**Jacksonville Electric
Authority
St. Johns River Power
Park**

Final
Environmental Impact Statement

Proposed Issuance of A New Source National
Pollutant Discharge Elimination System Permit

EXECUTIVE SUMMARY FOR
FINAL ENVIRONMENTAL IMPACT STATEMENT

Figure 7. Relationship of the main site and Blount Island to the historically (FEMA-defined) 100-year floodplain. Shaded areas indicate extent of historically defined 100-year flood.

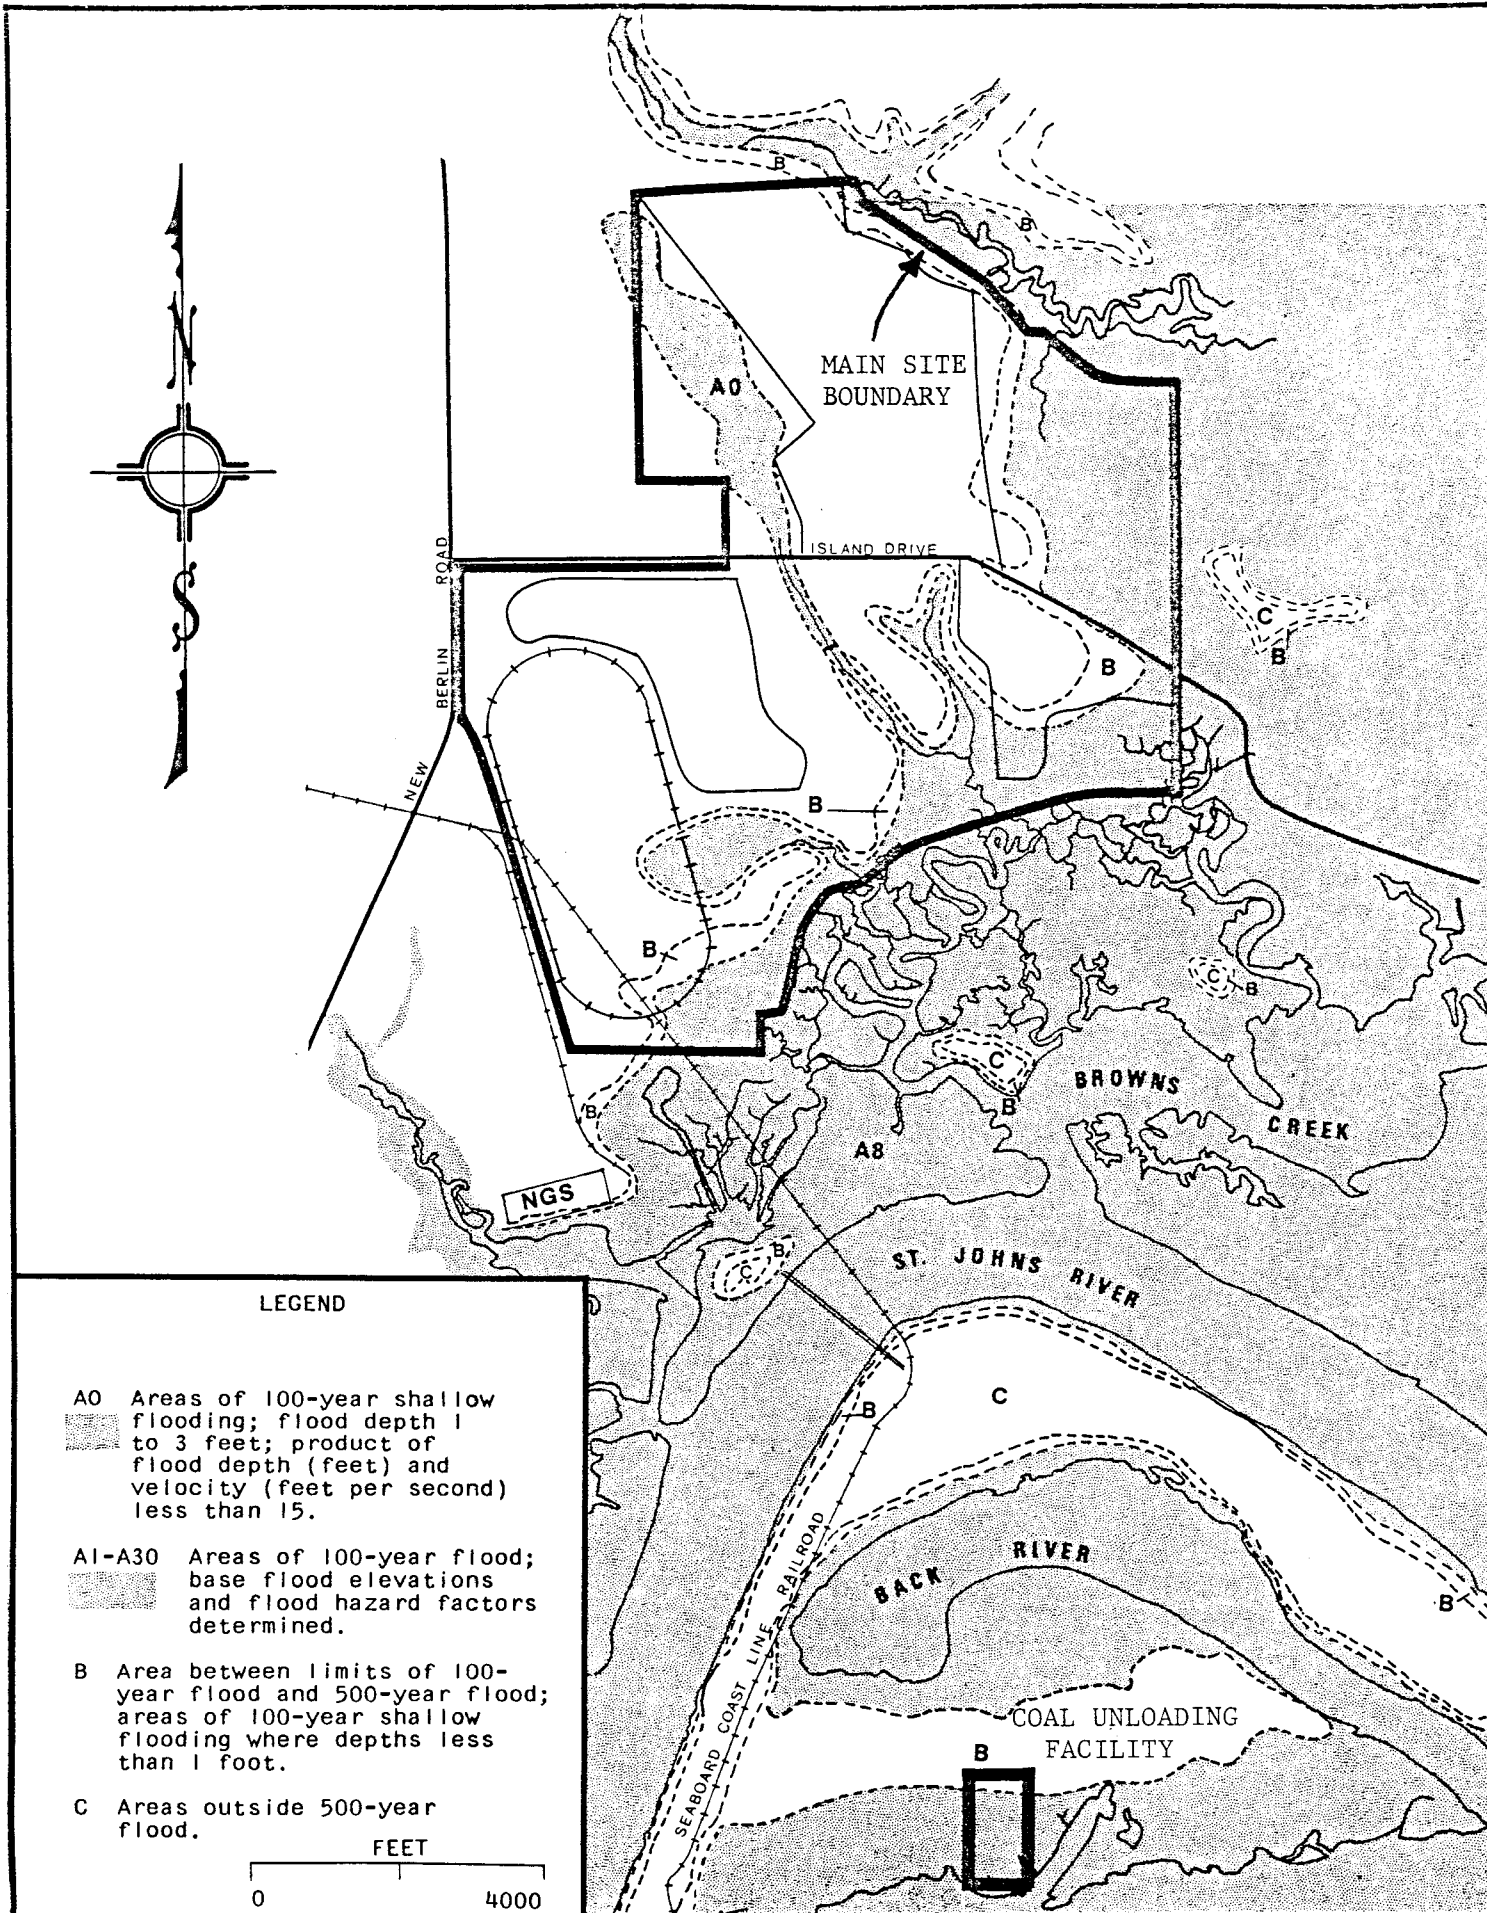
7' = This figure (or another one like it) should also show the 1% annual probability storm high water line; solid waste disposal area B (see Fig 2.2-2) is mostly below this level.

W-8: In order to address the comment, the most recent information concerning floodplains on the project site has been obtained. This information includes the 1977 FEMA floodplain map as well as additional detailed, site-specific information generated by the JEA. Figures 7 and 8 summarize this information in graphic form.

As shown in Figure 7, several areas of the main site are located within the historical (FEMA-defined) 100-year floodplain. These areas include a portion of the zone associated with the rail loop and small parts of solid waste disposal area A (and possibly area B) as well as other areas. A large part of the coal unloading facility on Blount Island is also located within the historical (FEMA-defined) 100-year floodplain.

- W-84: Figure 7 illustrates the relationship of the site to the FEMA-defined historical floodplain. As shown in the figure, only a small area of solid waste area B is actually within the 100-year floodplain. Refer to the response to comment W-8 for details concerning floodplain boundaries and impacts of the project on floodplains.

Figure 9. Mercury concentrations in the NGS/SJRPP mixing zone for FGD waste concentrations of 70 $\mu\text{g/l}$ and 7 $\mu\text{g/l}$ of mercury and an ambient river concentration of 0.6 $\mu\text{g/l}$ (Envirosphere 1982).

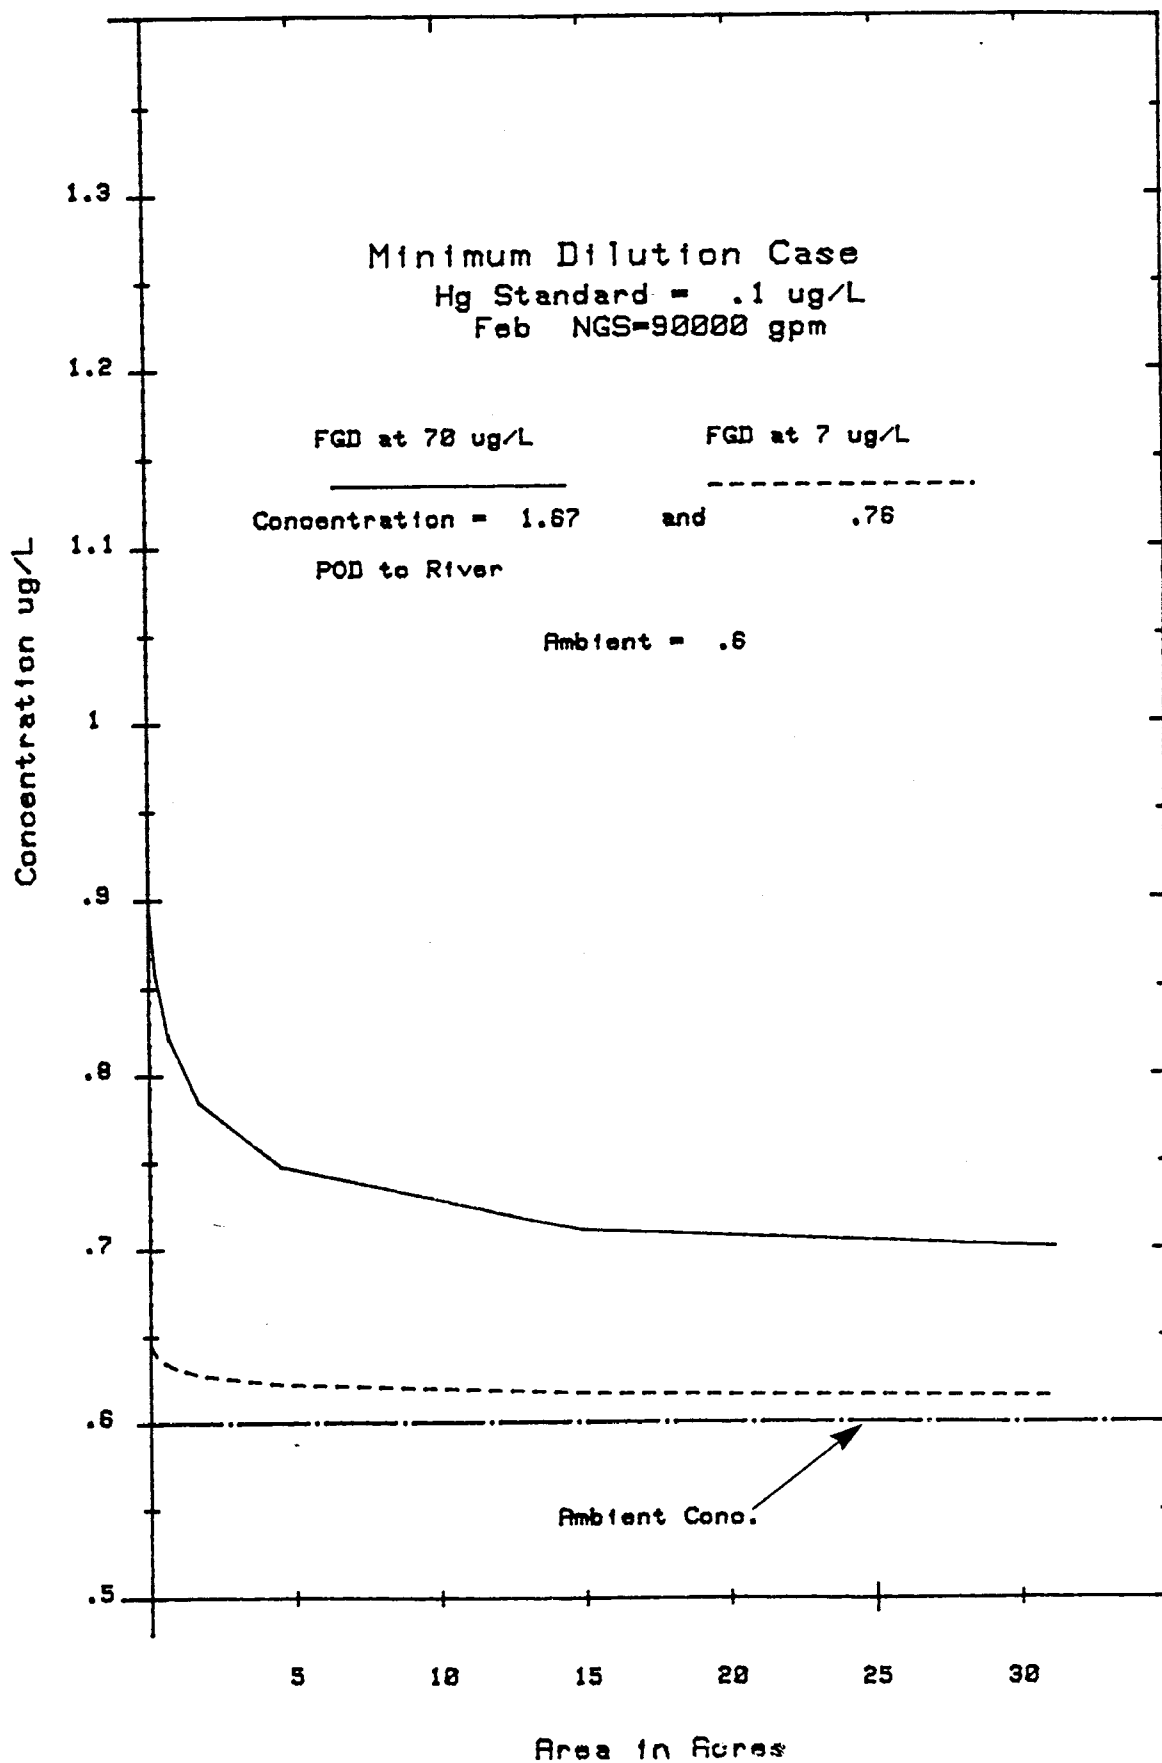
W-17: This comment refers to the discharge of heavy metals, particularly mercury, from the proposed SJRPP and the effect of these discharges on the water quality of Browns Creek and the St. Johns River and the effect of any potential bioaccumulation of mercury on the local fishery. The sources of wastewater discharge from the proposed SJRPP are described in Sections 2.2.6 and 2.2.7 and shown in Figure 2.2-8 of the Draft EIS.

Wastewater discharges from the SJRPP will increase the concentration of pollutants of concern in the plant's 31 acre mixing zone. Because of the potential effects of bioaccumulation on the quality of the fishery, mercury is of particular concern. Mercury will be discharged primarily from two sources; cooling tower blowdown and flue gas desulfurization (FGD) wastewaters. The cooling system will withdraw water from the NGS discharge channel, concentrate it 1.5 times by evaporation, and discharge blowdown back to the NGS discharge channel. This will increase the concentration of mercury in the mixing zone, but will result in no net increase in the quantity of mercury in the River. However, the FGD wastewaters contain mercury and other pollutants derived from burning coal. The variance from Class III water quality standards requested by JEA was based on the expected quality of wastewater generated by the various systems and FDER is considering the magnitude of the variances which may be granted based on the JEA estimates. The mercury contribution of the FGD system alone is of particular interest because at a discharge concentration of 70 ug/l as projected by JEA, it would constitute, under average conditions, more than 99% of the mercury from the plant processes and about 3.7% of the total mercury in the river under low flow conditions. USEPA has analyzed the literature available on FGD systems and has found that a more appropriate estimate of the concentration of mercury in the FGD waste is an order of magnitude lower, about 7 ug/l. The predicted concentration of mercury in the mixing zone using worst case operating conditions (minimum dilution flow via NGS and average discharge from SJRPP) and an FGD system discharge of 7 ug/l mercury is 0.76 ug/l as seen in Figure 9 (Envirosphere 1982). This concentration is a reduction by more than 50 percent of the JEA's predicted POD mercury concentration of 1.67 ug/l using 70 ug/l as FGD system input. Using 7 ug/l case for the FGD system contribution alone, the mercury concentration at the POD can be reduced from 16 times the water quality standard of 0.1 ug/l to 7 times the standard. This, of course, is during the periods when the ambient River quality itself exceeds the mercury standard by 6 times, a situation observed during pre-application monitoring. Also notable is the reduction in concentration at the boundary of a 31 acre mixing zone from 0.7 ug/l to

about 0.61 ug/l for the 70 ug/l and 7 ug/l cases, respectively. With ambient conditions at 0.60 ug/l mercury, a mixing zone concentration of 0.61 ug/l is approximately a 2 percent increase compared to the 17 percent for the 70 ug/l mercury.
